UNITED STATES
DEPARTMENT OF THE INTERIOR
BUREAU OF LAND MANAGEMENTFORM APPROVED
OMB NO. 1004-0135
Expires: July 31, 2010**SUNDRY NOTICES AND REPORTS ON WELLS**
*Do not use this form for proposals to drill or to re-enter an abandoned well. Use form 3160-3 (APD) for such proposals.***SUBMIT IN TRIPLICATE - Other instructions on reverse side.**

Devon Energy Production Company, L.P. respectfully requests to run a FMC multibowl wellhead system on the Big Sinks 25 Fed Com 3H.

Big Sinks Draw 25 Fed Com 3H – BOP Change

PECOS DISTRICT
CONDITIONS OF APPROVAL

PRIMARY MODE

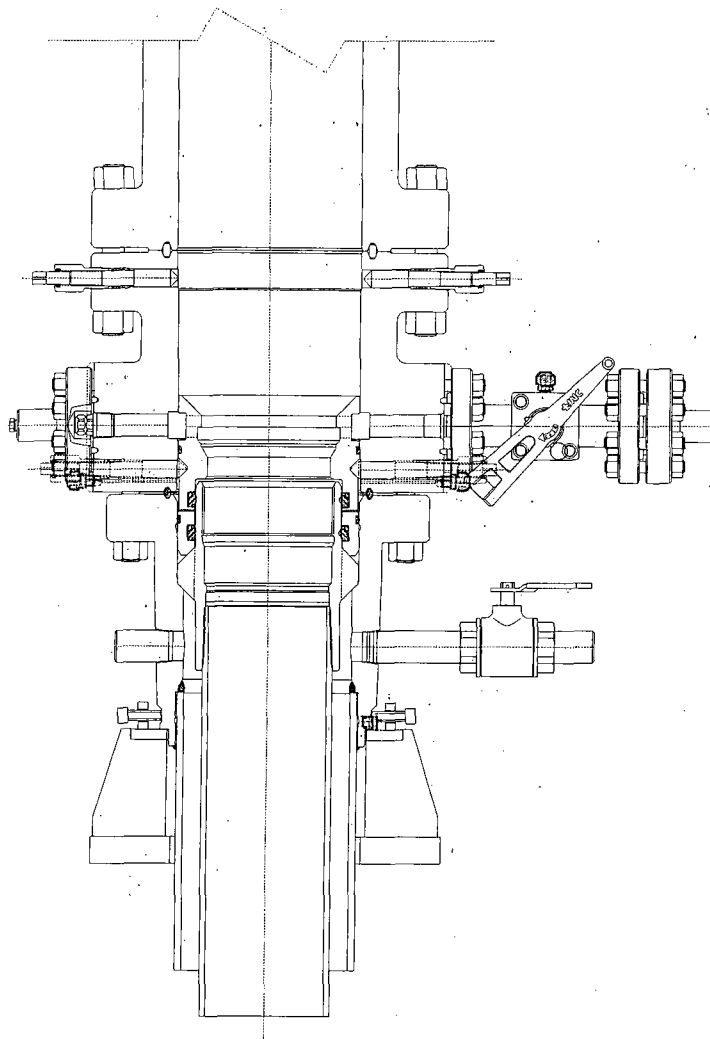
Devon proposes using a multi-bowl wellhead assembly (FMC Uni-head). This assembly will only be tested when installed on the surface casing. Minimum working pressure of the blowout preventer (BOP) and related equipment (BOPE) required for drilling below the surface casing shoe shall be 3000 (3M) psi.

- Wellhead will be installed by FMC's representatives.
- If the welding is performed by a third party, the FMC's representative will monitor the temperature to verify that it does not exceed the maximum temperature of the seal.

- FMC representative will install the test plug for the initial BOP test.
- FMC will install a solid steel body pack-off to completely isolate the lower head after cementing intermediate casing. After installation of the pack-off, the pack-off and the lower flange will be tested to 3M, as shown on the attached schematic. Everything above the pack-off will not have been altered whatsoever from the initial nipple up. Therefore the BOP components will not be retested at that time.

- Devon will pressure test all seals above and below the mandrel (but still above the casing) to full working pressure rating.
- Devon will test the casing to 0.22 psi/ft or 1500 psi, whichever is greater, as per Onshore Order #2.

After running the 13-3/8" surface casing, a 13-5/8" BOP/BOPE system with a minimum rating of 3M will be installed on the FMC Uni-head wellhead system and will undergo a 250 psi low pressure test followed by a 3,000 psi high pressure test. The 3,000 psi high and 250 psi low test will cover testing requirements a maximum of 30 days, as per Onshore Order #2. If the well is not complete within 30 days of this BOP test, another full BOP test will be conducted, as per Onshore Order #2.

After running the 9-5/8" intermediate casing with a mandrel hanger, the 13-5/8" BOP/BOPE system with a minimum rating of 3M will already be installed on the FMC Uni-head.

3. **Operator has proposed a multi-bowl wellhead assembly. This assembly will only be tested when installed on the surface casing. Minimum working pressure of the blowout preventer (BOP) and related equipment (BOPE) required for drilling below the surface casing shoe shall be 3000 (3M) psi.**

- a. **Wellhead shall be installed by manufacturer's representatives, submit documentation with subsequent sundry.**
 - b. **If the welding is performed by a third party, the manufacturer's representative shall monitor the temperature to verify that it does not exceed the maximum temperature of the seal.**

- c. **Manufacturer representative shall install the test plug for the initial BOP test.**
 - d. **Operator shall perform the intermediate casing integrity test to 70% of the casing burst. This will test the multi-bowl seals.**

- e. **If the cement does not circulate and one inch operations would have been possible with a standard wellhead, the well head shall be cut off, cementing operations performed and another wellhead installed.**

CONTINGENCY MODE

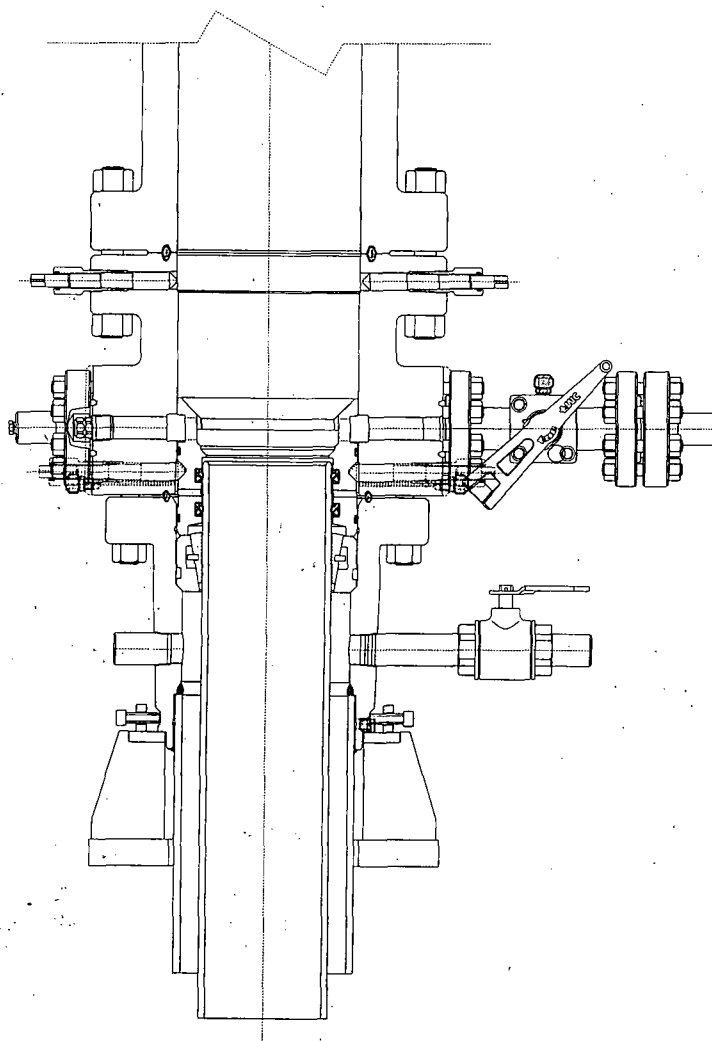
- If the cement does not circulate and one inch operations would have been possible with a standard wellhead, the well head will be cut and top out operations will be conducted.
